Land Transport Rule: Traffic Control Devices Amendment 2019

Land Transport Rule
Traffic Control Devices Amendment 2019
Rule 54002/2004/12

Objective of the Rule	i
Extent of consultation	ii
Part 1 Rule requirements	1
Section 1 Preliminary provisions	1
1.1 Title	1
1.2 Commencement	1
1.3 Principal Rule amended	1
Section 2 Amendments to principal Rule	1

M2-3C: Cycle path or shared path crossing driveway.

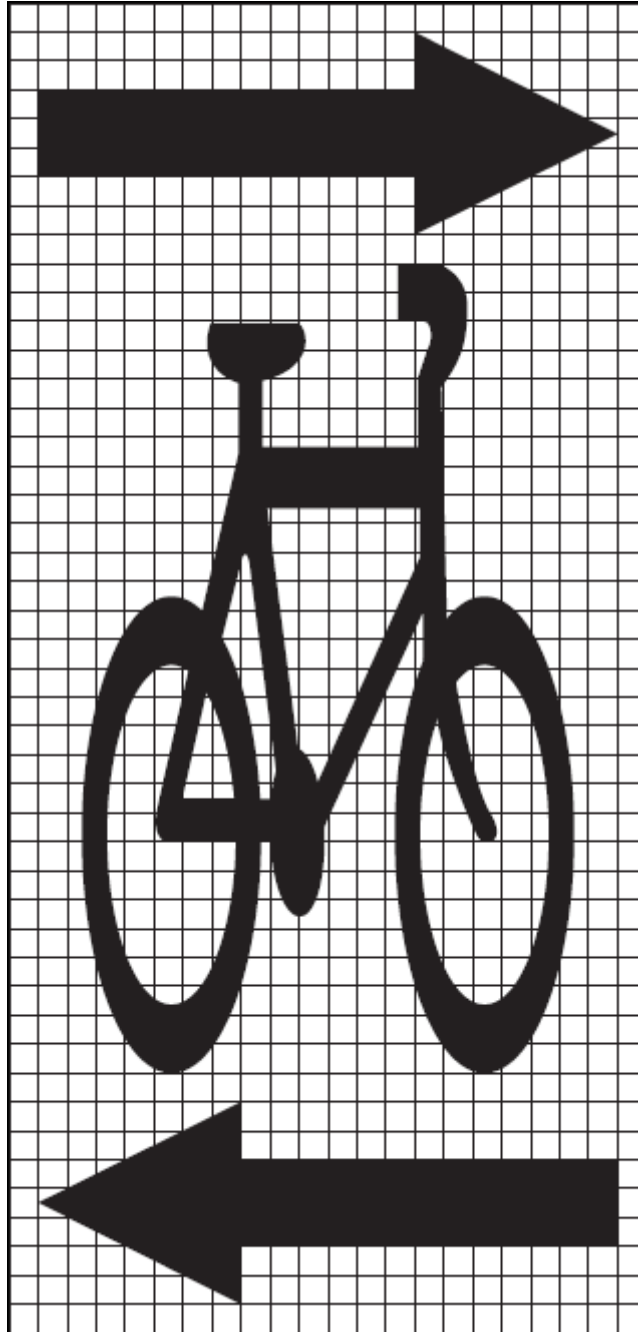
2.13(5) In *Schedule 2*, insert the items set out in *Schedule 2* of this Rule in their appropriate alphabetical order.

Note: for a one-way path, either arrow may be omitted and the cycle symbol may be reversed so that the remaining arrow and the cycle symbol indicate the direction of travel.

M2-3E: Alternative cycle symbol marking for shared paths

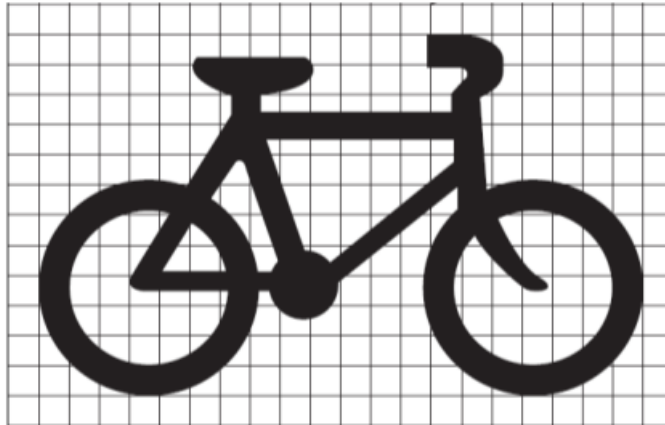
Note: for a one-way path, either arrow may be omitted and the cycle symbol may be reversed so that the remaining arrow and the cycle symbol indicate the direction of travel.
